City of Kitchener  
**PRE-SUBMISSION CONSULTATION COMMENT FORM**

Project Address: 22 Weber

Application Type: Site Plan & ZBA/OPA

**From:** Victoria Grohn  
**Sent:** Friday, September 25, 2020 4:21 PM  
**To:** 'vhicks@mhbcplan.com'; Dan Currie  
**Cc:** Juliane vonWesterholt  
**Subject:** 22 Weber Street - Draft HIA

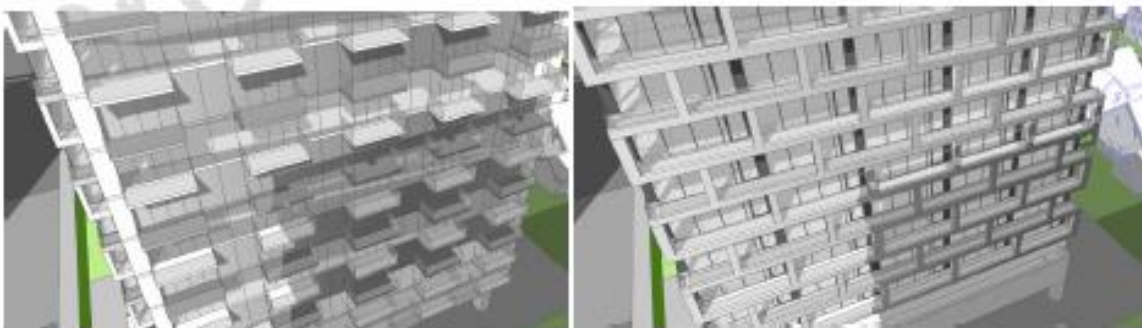
The heavy architectural framing around the west elevation balconies is a quality design response to protect resident privacy against future adjacent intensification. I measure a depth of 1.7m for these balconies, including structure. This must be considered an absolute minimum and we should push for 2.0m or greater. The depth of the hanging balconies on the east elevation are similarly critical for a tower that does not meet separation. I have them at 1.8m currently. Again, this must be considered the absolute minimum through to final approvals, with 2.0m preferred.

The enclosed balconies on the west elevation are much better at protecting for resident privacy than the hung balconies on the east elevation. They will also help to provide shade for interior spaces much more effectively, and so it is appropriate that they are on the west elevation, where summer afternoon sun will have a much greater impact on energy performance and occupant comfort than the morning-to-

**Push for balcony depths in excess of 2m and ensure at a minimum that the balcony depths remain at 1.8m minimum through to final approval.**

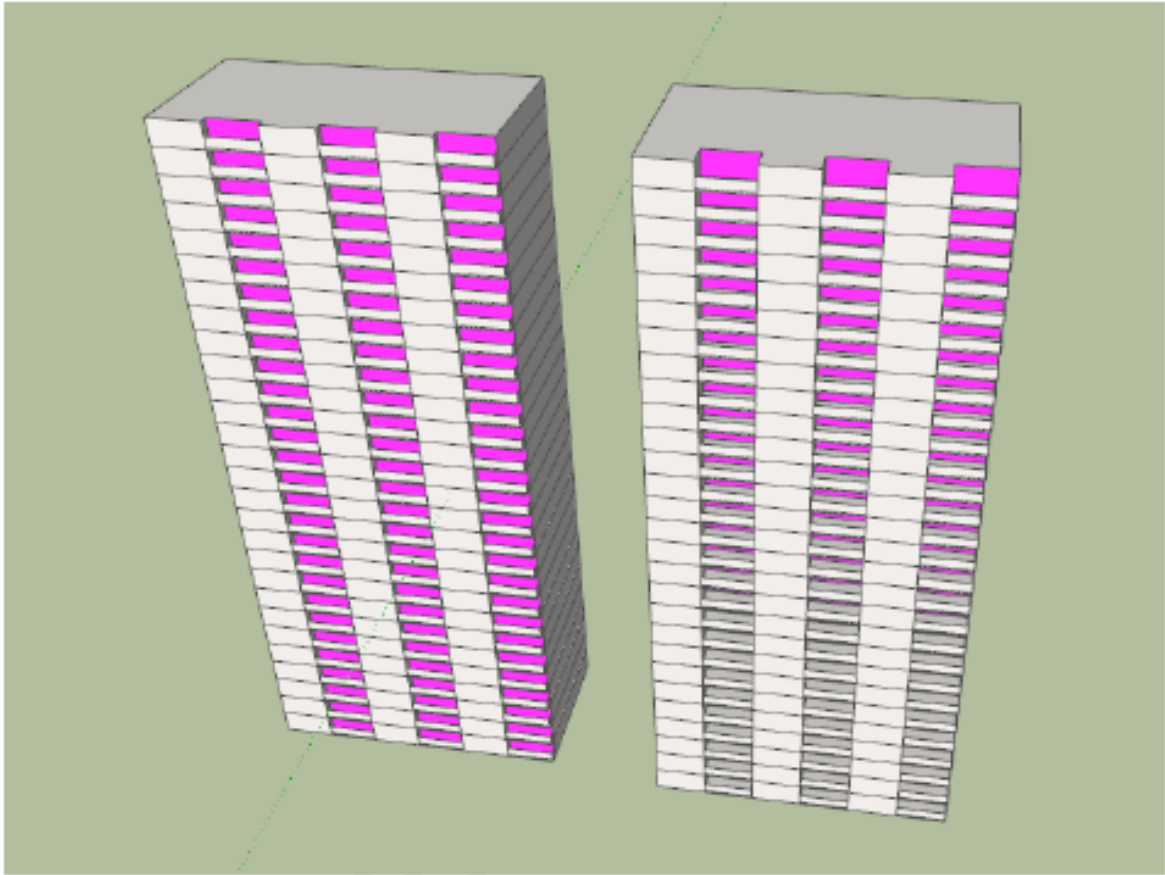
Because this building does not meet its separation targets, it will be setting a precedent here that nearby developments will use to justify their own proposals. We have to mitigate against these outcomes as best we can if we are going to support development that fails to meet our design targets. In this case, the surrounding context suggests that a future tower to the east will be much closer than one to the west, as we see in this conceptual image:

As seen here, the next closest tower to the east may be only 20m away. The next closest tower to the west should be over 50m away. This means that, if the proposed tower at 22 Weber cannot meet its separation target, its architecture will need to protect for occupant privacy in other ways. One effective way would be to enclose the east-facing balconies in a similar way to those on the west side of the building. Below are two images which demonstrate the increased privacy of providing enclosed balconies vs. hung balconies, and this is, again, where balcony depth has significant impact;

**Enclose or otherwise design the east-elevation balconies to provide increased privacy for occupants, as a future tower could be located within 20m.**

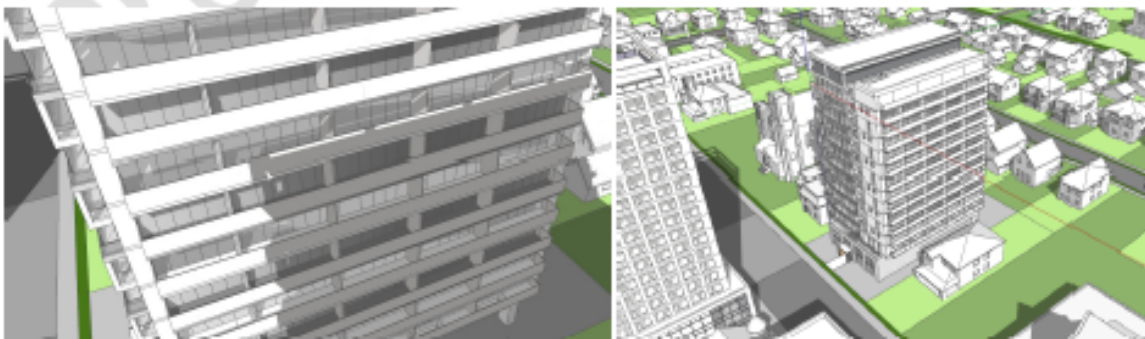
It may not be immediately obvious, but views into interior living spaces are dramatically decreased. This is a recommendation that should be implemented easily, as it should have minimal or no impact on cost, layout, design, parking, unit yield etc. This effect can be seen more clearly in the following diagram;

Here, the magenta clearly shows how much more visible interior living spaces are with shallow balconies compared to deep balconies. Enclosing balconies has a significant, similar impact.
